WHITEMARSH TOWNSHIP PLANNING COMMISSION

MEETING OF JULY 28, 2020 6:00 PM

- Review (continued) SLD #05-14; 901 Washington Partners, LP/901 Washington Street
Revised Preliminary Plan; 62 Townhomes

**Reference: RIVERplace
901 Washington Street Townhomes
Zoning Ordinance Compliance Review and Preliminary Plan Review Responses
Whitemarsh Township, Montgomery County, PA
Nave Newell No. 2009-134.05**

4 of 23

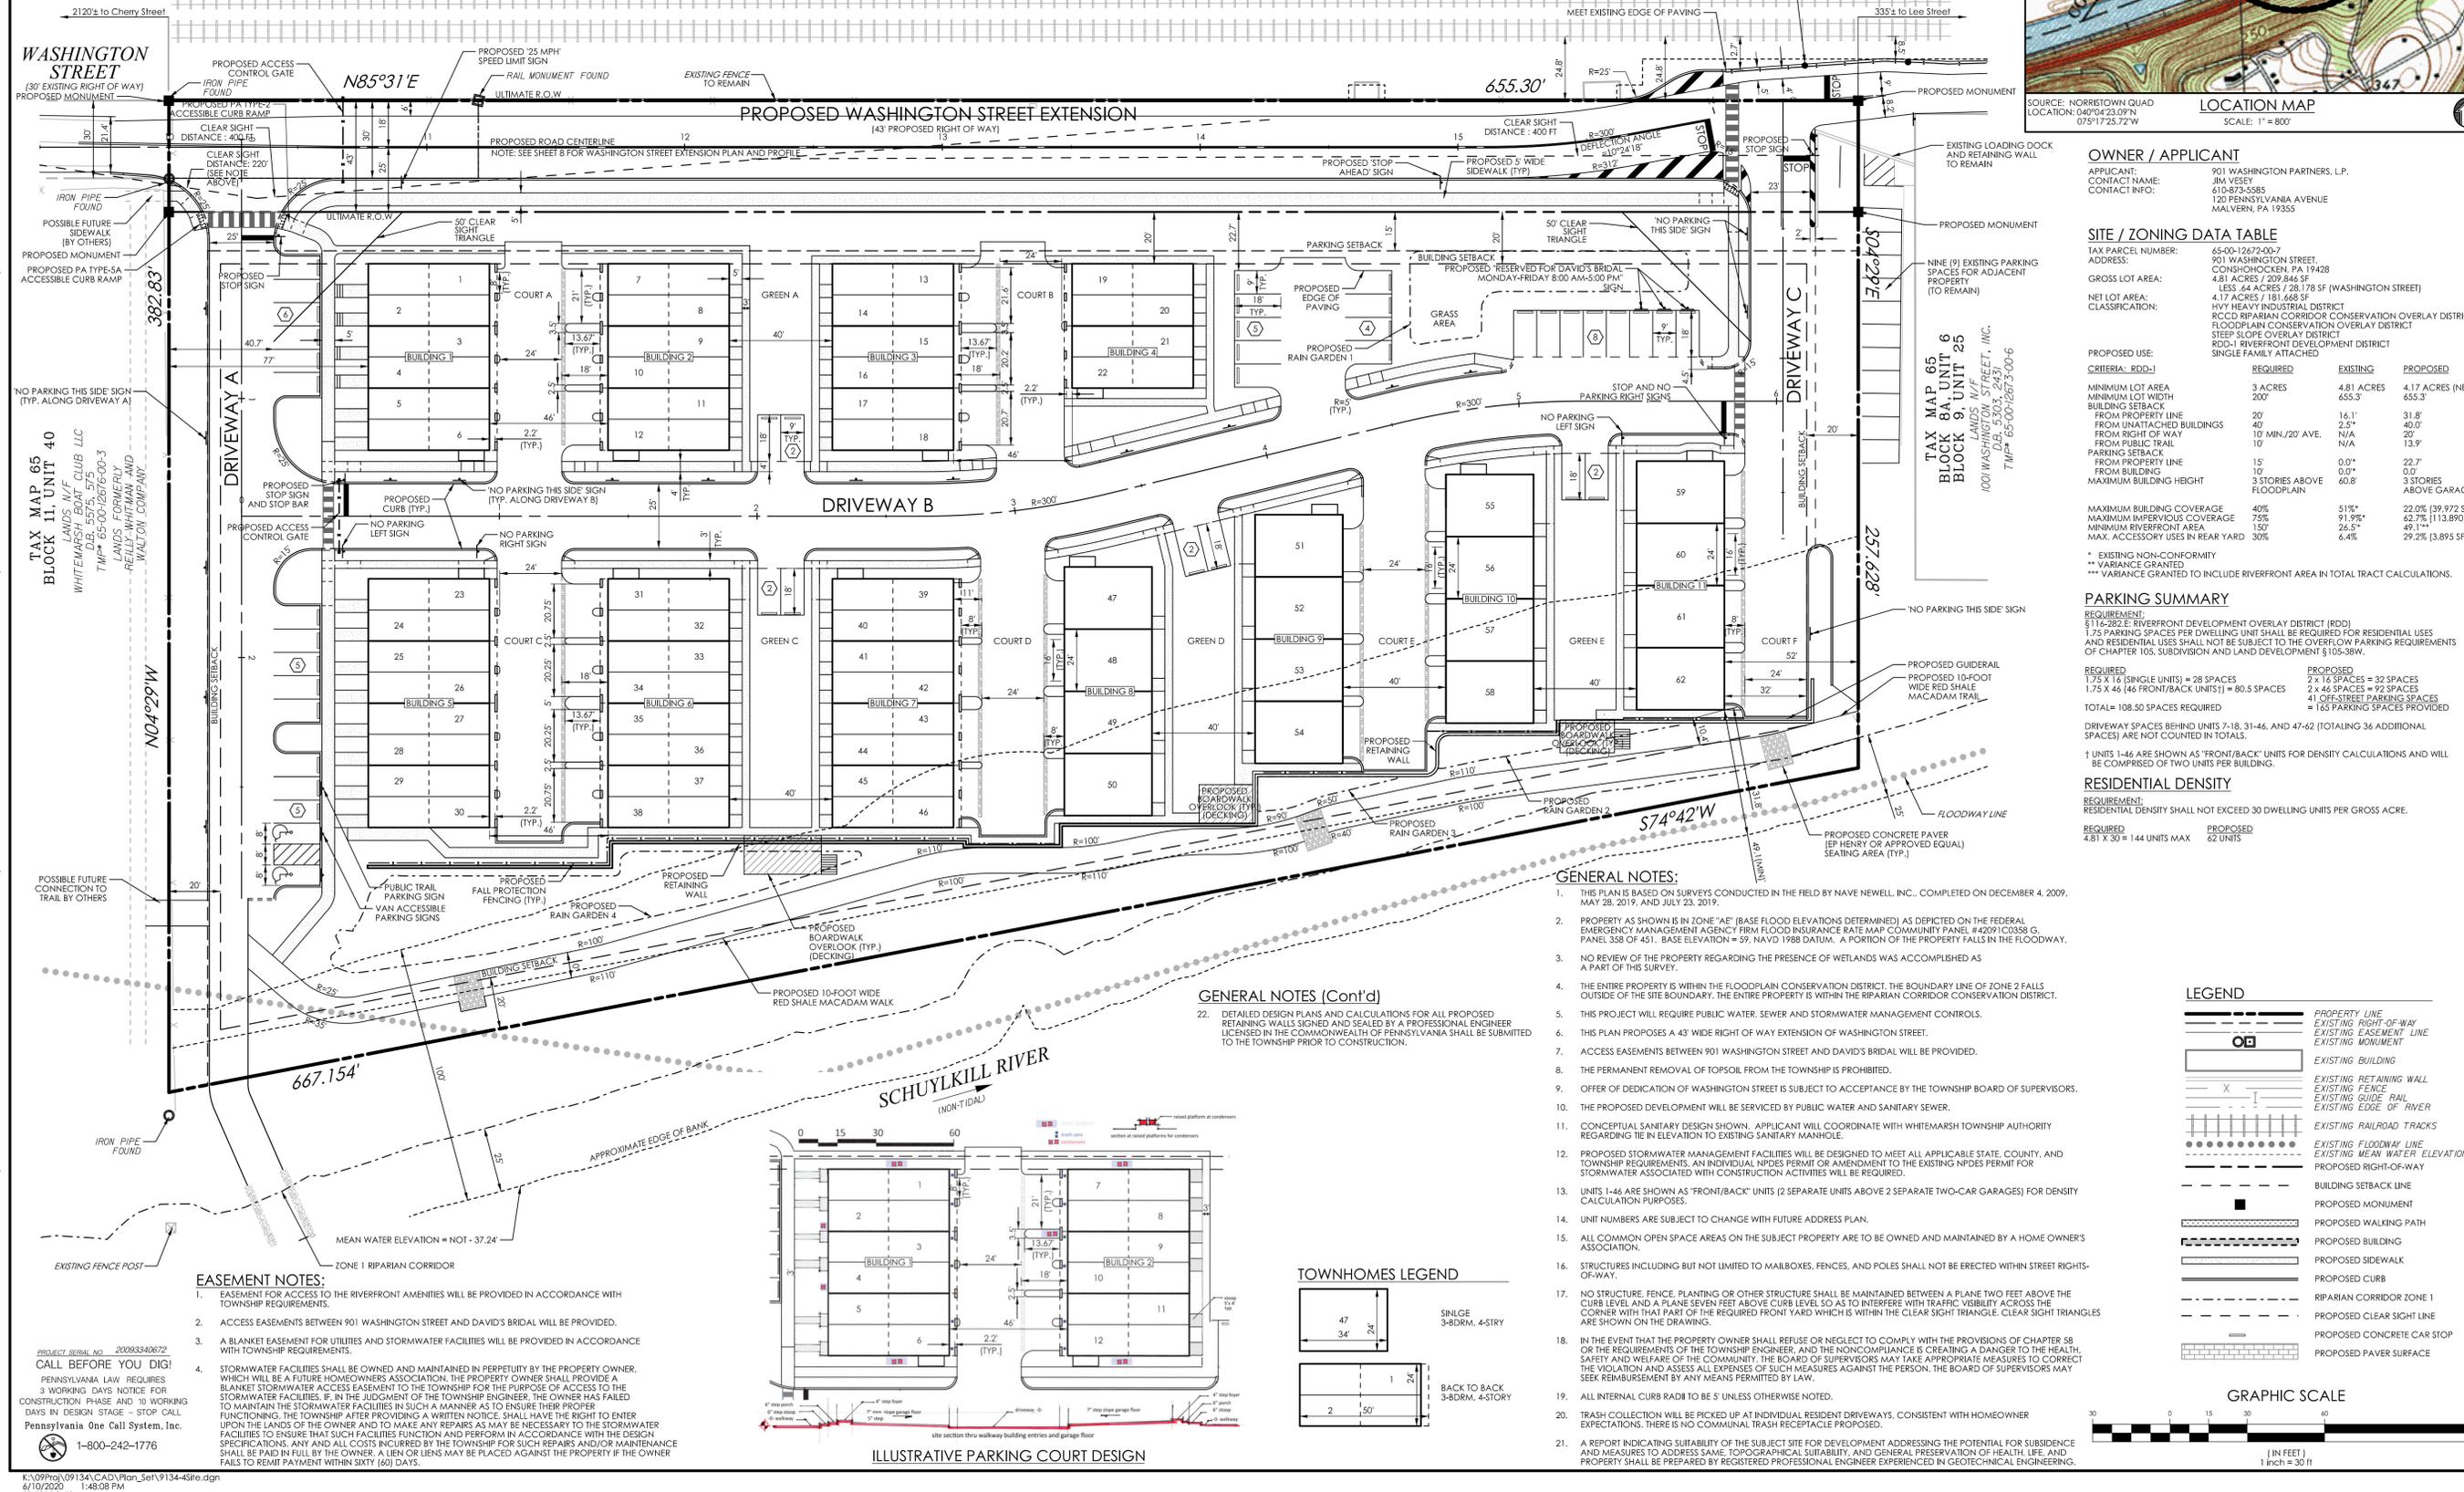
1. **Site Plan:** We have added two ADA parking spaces and a sign labeling "public trail parking" to the parking area near the riverfront trail, as requested by the Planning Commission.

We are now showing the existing fence along the railroad property as "to remain". This fence will be kept and the existing vegetation cleaned up in order to provide a better visual buffer between the project property and the railroad.

We have also added "no parking" signs along the north side of Driveway B, as the Planning Commission requested. We have rerun the turning movements for Whitemarsh Township's largest fire truck and that truck can successfully maneuver along Driveway B with cars

parked along the southern side of Driveway B, except near the intersections with Driveway A and Driveway C. We have added "no parking" signs in these areas.

TREE SURVEY PLAN

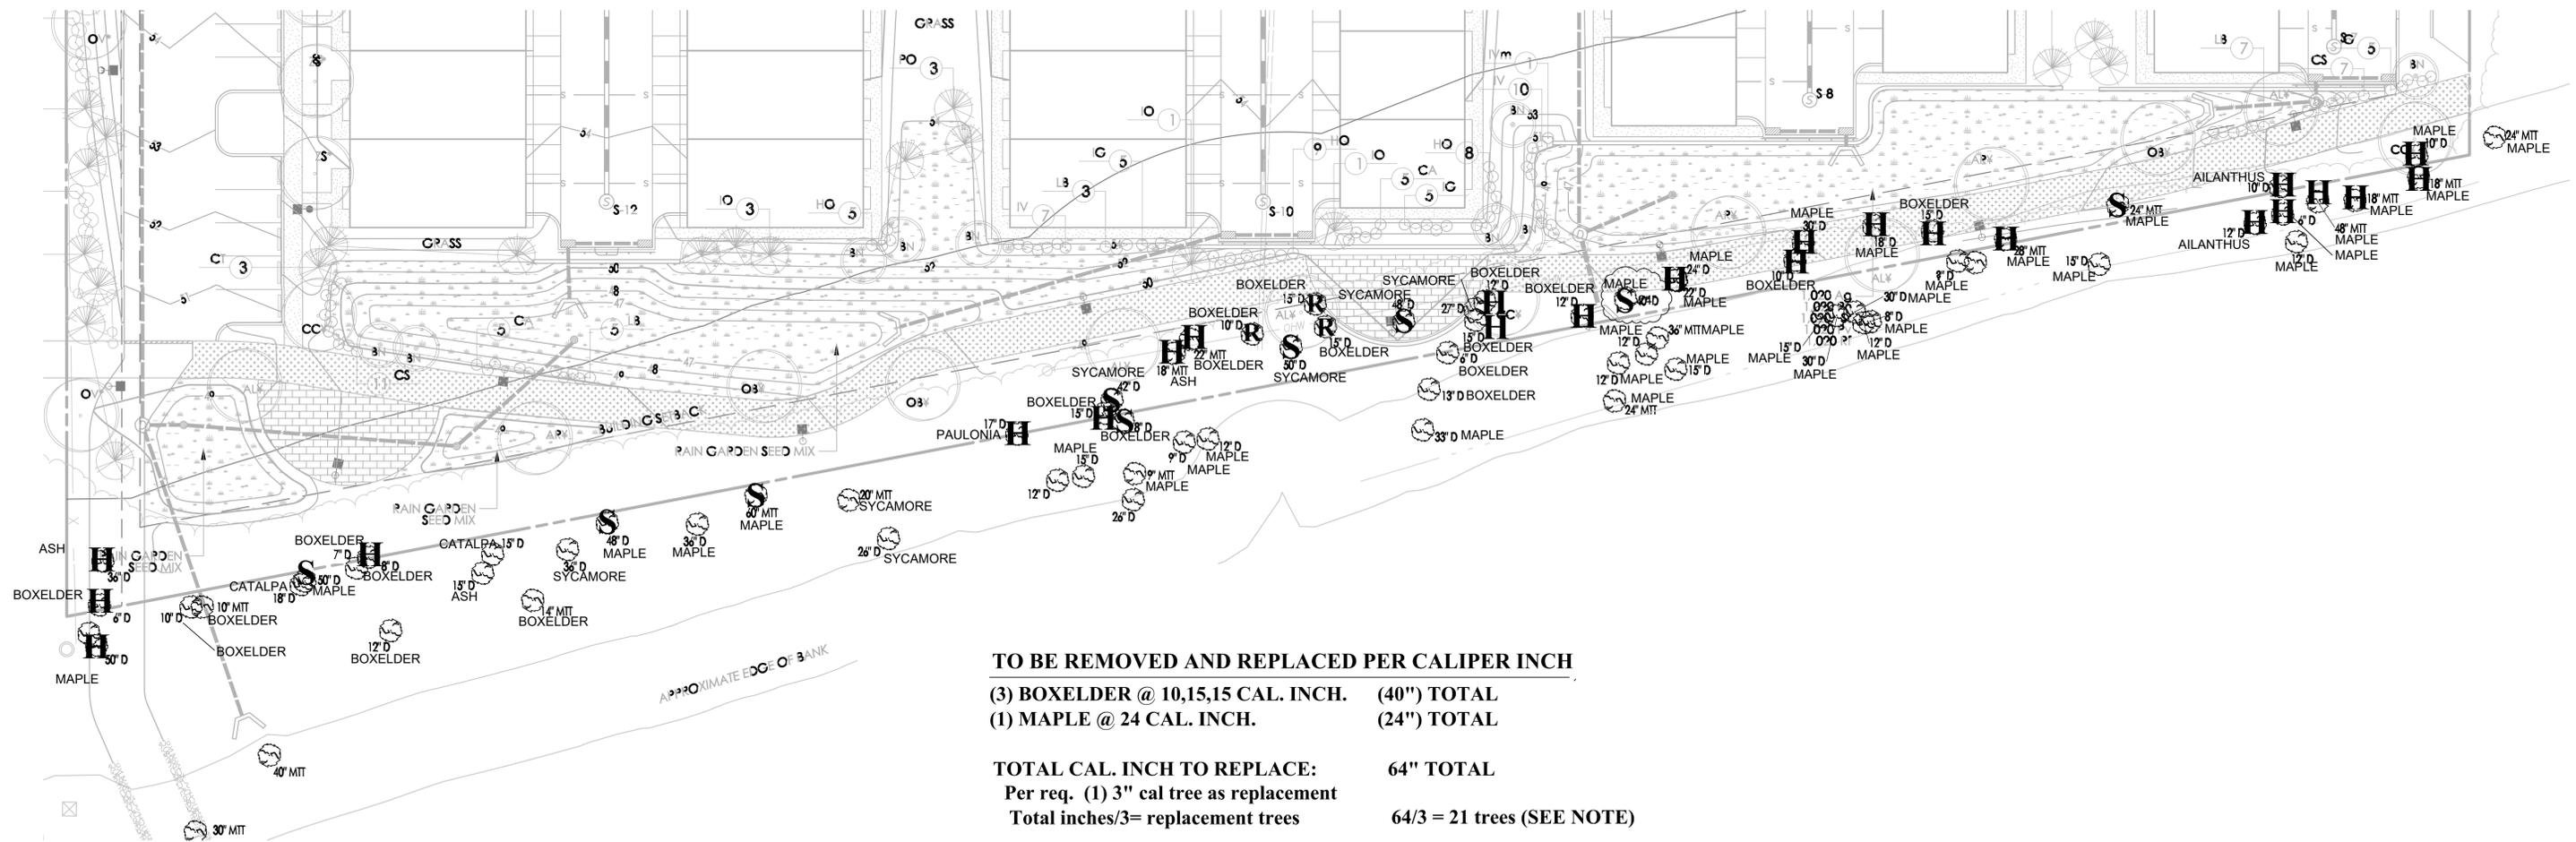
2. **Tree Survey Plan:** We have included a copy of this plan, as the Planning Commission requested. This plan shows the existing trees on the site and labels the following way: hazard trees; trees to be removed and replaced; and the trees to be saved.
3. **Landscape Plan:** We have revised this plan to show the existing trees that are to remain along the rear of the property near the river. We have also updated the "planting requirements vs. provided" table and the landscape schedule to reflect the current design.

The applicant is removing a total of 18 hazard trees. These were confirmed during our walkthrough. In addition, they are removing 3 trees (no heritage) that will require 64 inches to be replaced or 21 3" trees. they are requesting a waiver to increase the percentage of shrubs from 20% to 43% for better stabilization of the riparian corridor, to decrease the percentage of trees from 50% to 27%, and to provide replacement trees at the rate of three (3) one inch caliper trees for each (1) three inch caliper tree required in order to improve the viability of trees planted on the riparian slope. (see revised Landscape plan).

PCSM / LANDSCAPE PLAN
901 Washington Street
TOWNHOUSE LAYOUT
RIVERplace
WHITEMARSH TOWNSHIP, MONTGOMERY COUNTY, PENNSYLVANIA

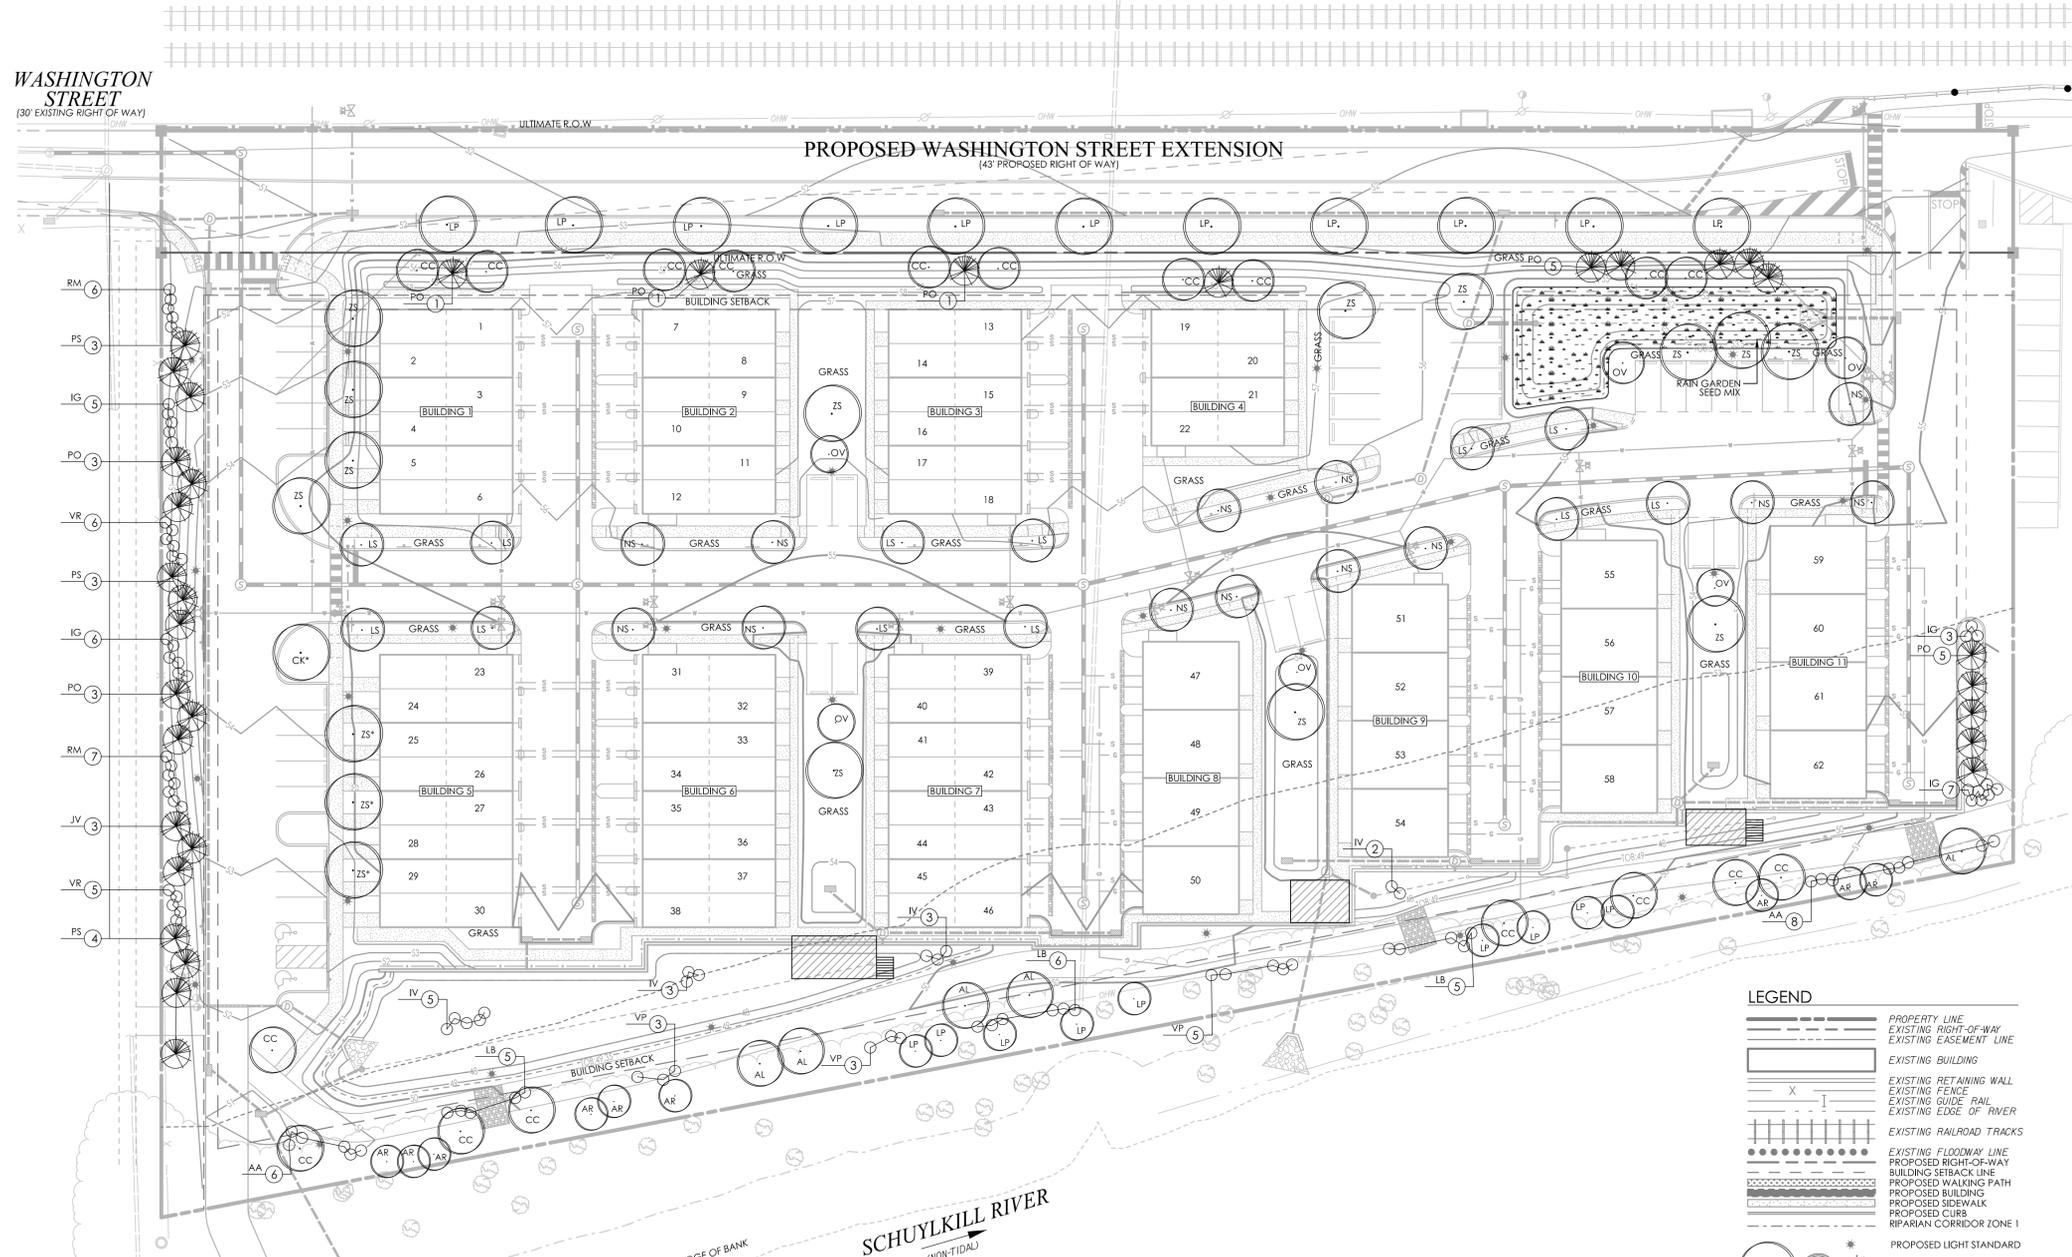
At the Planning Commission's request, we considered substituting a native sycamore for the London Plane trees that we are proposing. The project's landscape architect has recommended that we keep the London Plane along the riparian corridor because this species of tree has been bred to resist the anthracnose virus, which the existing native sycamores along the river all suffer from. These proposed plantings will be discussed with the Shade Tree Commission.

I would like the applicant to further explain, in detail, the basis and benefits of utilizing the 1" stock and more shrubs so that the STC can review the objectives prior to the meeting so they have a full understanding of the concept.

In addition, I would like to see a deer protection detail for the smaller trees, a maintenance plan to manage the invasive plants and a more diverse palate of plants for the shade trees.

* LONDON PLANE SUBSTITUTED FOR NATIVE SYCAMORE TO AVOID SUSCEPTIBILITY TO ANTHRACNOSE FUNGUS
